UNITED STATES PATENT AND TRADEMARK OFFICE

APPLICATION NO.	FILING DATE	FIRST NAMED INVENTOR	ATTORNEY DOCKET NO.	CONFIRMATION NO.
10/600,022	06/19/2003	Brent C. Gerberding	S63.2B-10964-US01	5691

SUPPLEMENTAR
Office Action Summary

Supplemental Action

FIG. 11

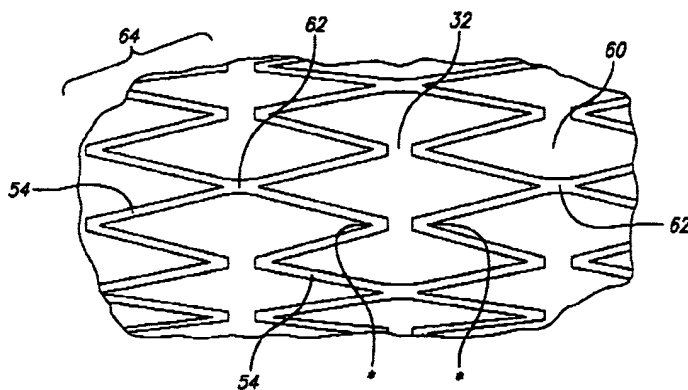
Edwin et al discloses a stent comprising a tubular framework having an outer surface and an inner surface and a plurality of interconnected struts, an outer covering

of PTFE and an inner covering of PTFE, the outer covering extending along at least a portion of the outer surface of the expandable framework, the inner covering extending along at least a portion of the inner surface of the expandable framework, at least a portion of the inner and outer coverings being contiguous, the stent further comprising at least one radiopaque marker disposed between the inner covering and the outer covering. See illustrations of figures 3-5 and corresponding supporting portions of the specification. While Edwin et al earlier patent US 6579314 illustrates one embodiment in which the serpentine bands including a linear connector strut attaching a peak of one band to a trough of another. (See figure 11).

Such configurations are well known in the prior art as shown by any of Rivelli, Jr. et al (7037330), Bales, et al (6878162), Richter et al (6156052) and Schnepf-Pesch et al (5707386). Moreover, Edwin does not disclose the particulars of the connector strut having at least one marker, however each of Ventura (2004/0044399), Burgermeister et al (20030069630) and Gladdish, Jr. et al (20020193867) illustrate

markers disposed on or in the connector strut. To place markers at the location of the connector strut would have been an obvious equivalence from the teachings of any of Ventura (2004/0044399), Burgermeister et al (20030069630) and Gladdish, Jr. et al (20020193867) based on design and engineering consideration. Moreover, conversely, to provide an inner and outer covering of ePTFE to the serpentine frame of any of Rivelli, Jr. et al (7037330), Bales, et al (6878162), Richter et al (6156052), Schnepf-Pesch et al (5707386), Ventura (2004/0044399), Burgermeister et al (20030069630) and Gladdish, Jr. et al (20020193867) to provide better compatibility and tissue response would have been obvious from the teachings of Edwin et al.
